# **DEVELOPMENT OF DRAFT CONSTRUCTION SAFETY STANDARDS FOR EXCAVATIONS**

DEVELOPMENT OF DRAFT CONSTRUCTION  
SAFETY STANDARDS FOR EXCAVATIONS

NBSIR 83-2693

The Occupational Safety and Health Act of 1970, Section 22(c)(1)(d)(2) authorizes the Director of NIOSH to make recommendations concerning improved occupational safety and health standards. The purpose of this document is to recommend to OSHA revised, updated language for improving 29 CFR 1926 Subpart P on Excavations, Trenching, and Shoring.

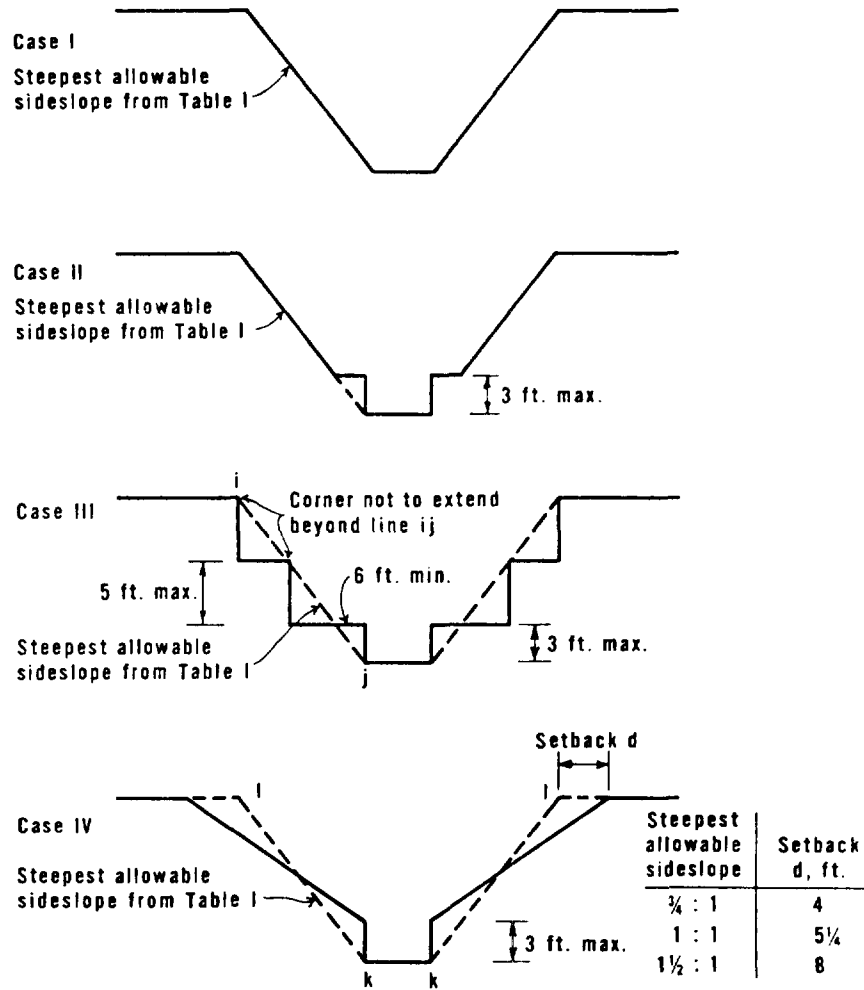
(<sup>b/</sup> ...Slopes shall be cut back to the stable (flatter) slope? Change Table 1 to use 3/4:1 maximum slope as the only limitation?)

It is obvious from the workshop discussions that the maximum allowable slopes are too severe for many regions. Thus, these sloping requirements are relaxed. To offset possible hazards resulting from this relaxation, footnote b) was modified to explicitly charge the competent person on the job with the responsibility of selecting a safe slope. This approach is also in line with the ASFE comment that stipulates slopes cannot be used "blindly."

Figure 2. Allowable configurations of sloped excavations (cases II, III, and IV are for short-term excavations)

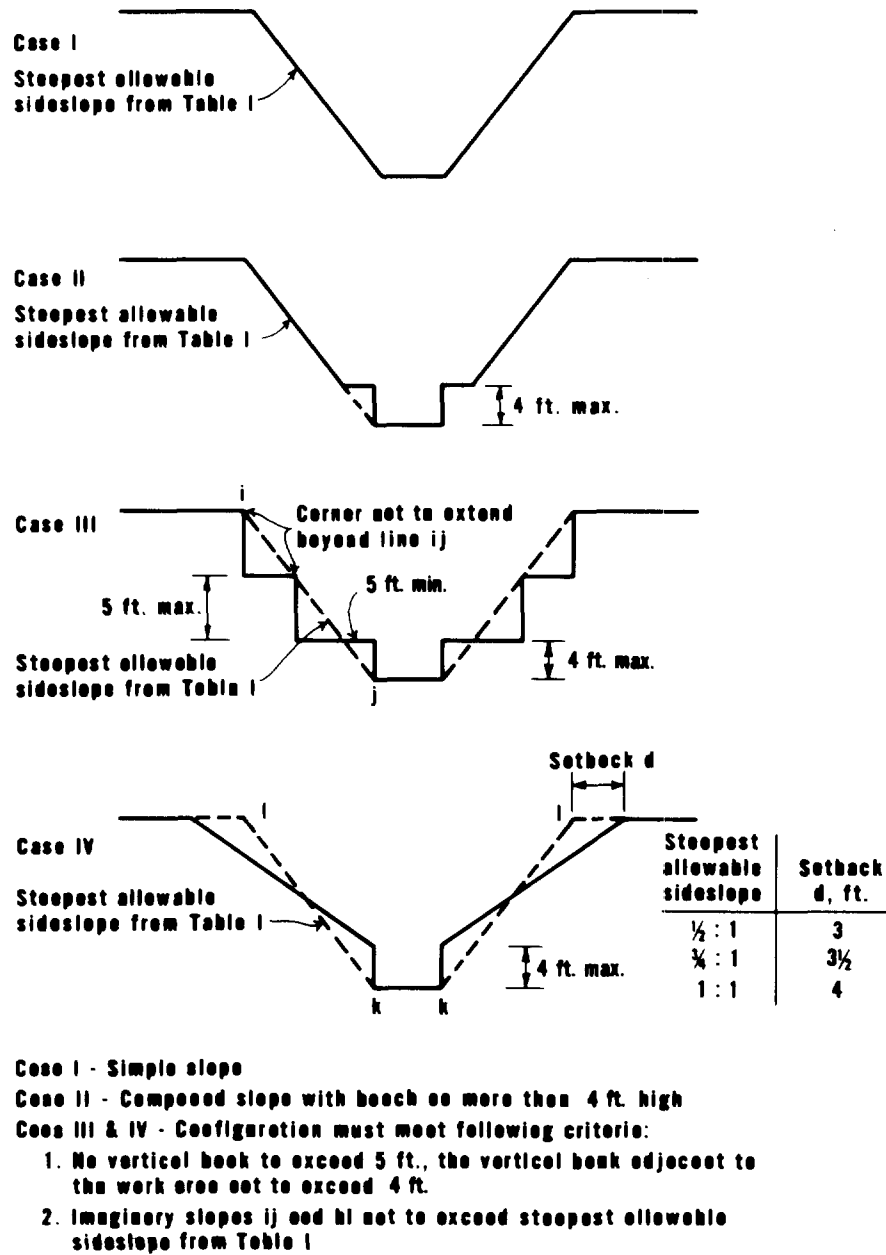
In the Dallas workshop, it was suggested by some contractors to increase the bank to 5 ft (workshop memo). AFL-CIO recommended to leave the allowable height at 3 ft. The point was made that if a large pipe is laid it would provide workers protection against collapse of the bank next to the work area.

6. Page 12. Figure 2: Should the allowable bank next to the work area in Cases II, III and IV be increased to 4 ft? Should "Case IV" be limited to excavation by trenching machines?

The revised sketch is a suggestion rather than a recommendation. It is recommended that industry try to reach agreement on the height of the allowable bank.

Figure 3. Determination of Adjusted Depth

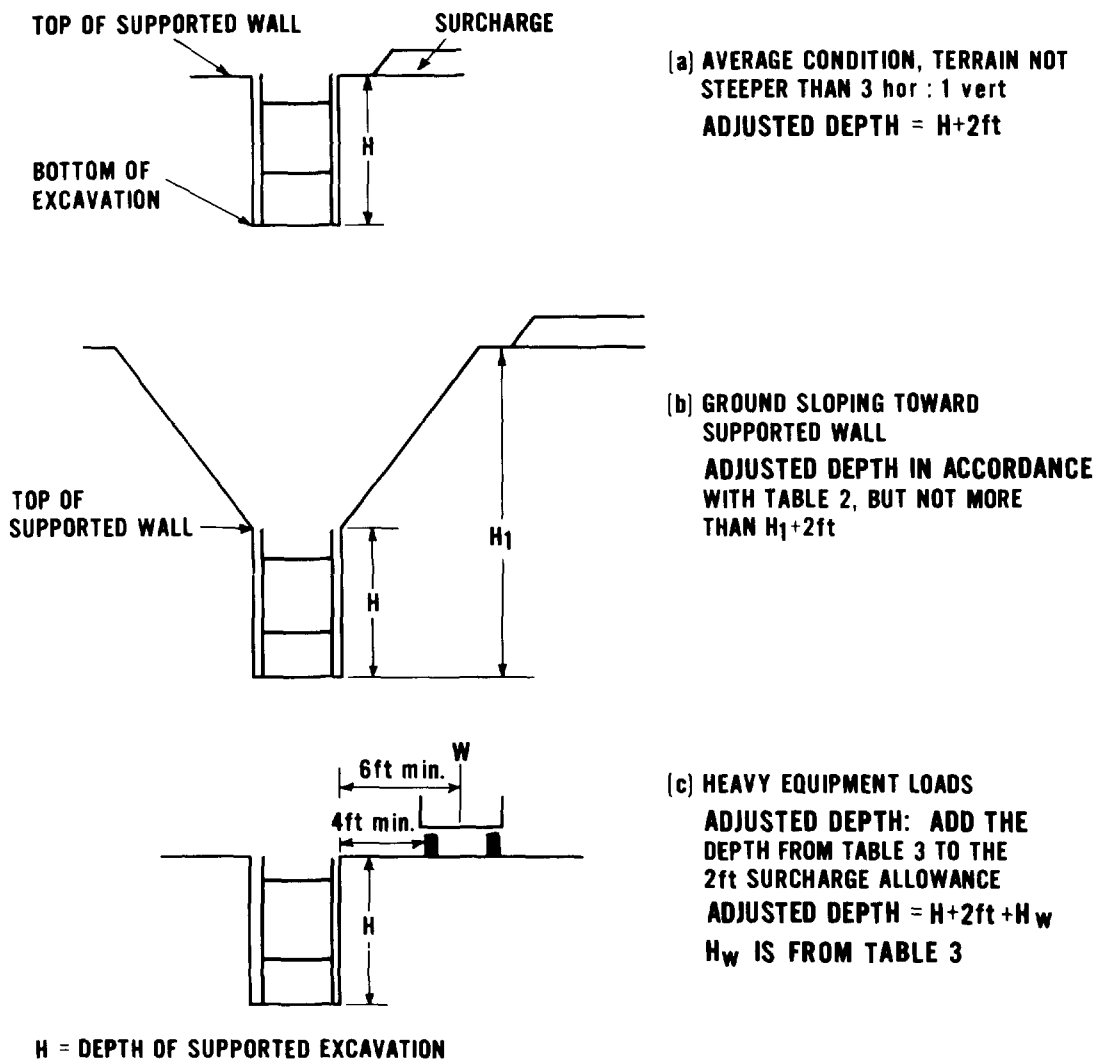
It was suggested to eliminate the protrusion of shoring, as this is many times not used, and frequently not desirable as a means of protection against rolling or sliding objects (Bradberry).

TABLES 2 and 3 NO CHANGE RECOMMENDED
